Ref: FCC Class II Permissive change for FCC ID: 2ADH6-190209LC

This is to request a Class II Permissive change for FCC ID: 2ADH6-190209LC originally granted on July 28, 2023.

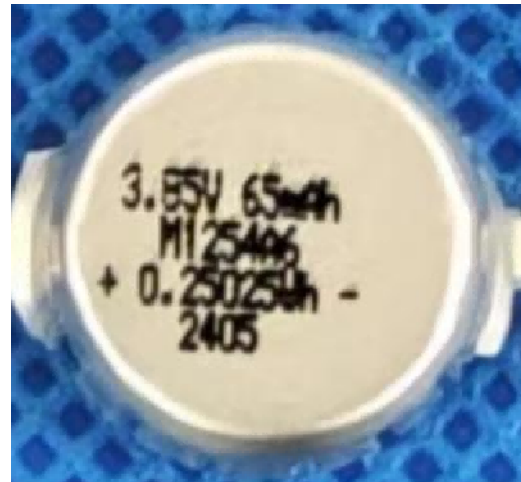
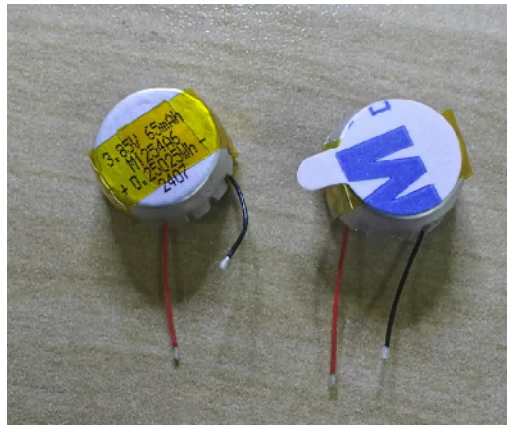
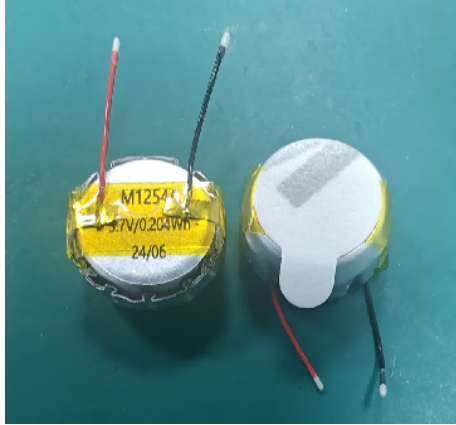
The headphone battery is changed from DC 3.7V to DC 3.85V 65mAh, and the charging bin circuit is changed: the Type-C seat is changed from 6PIN to 16PIN

Before change :

After the change:
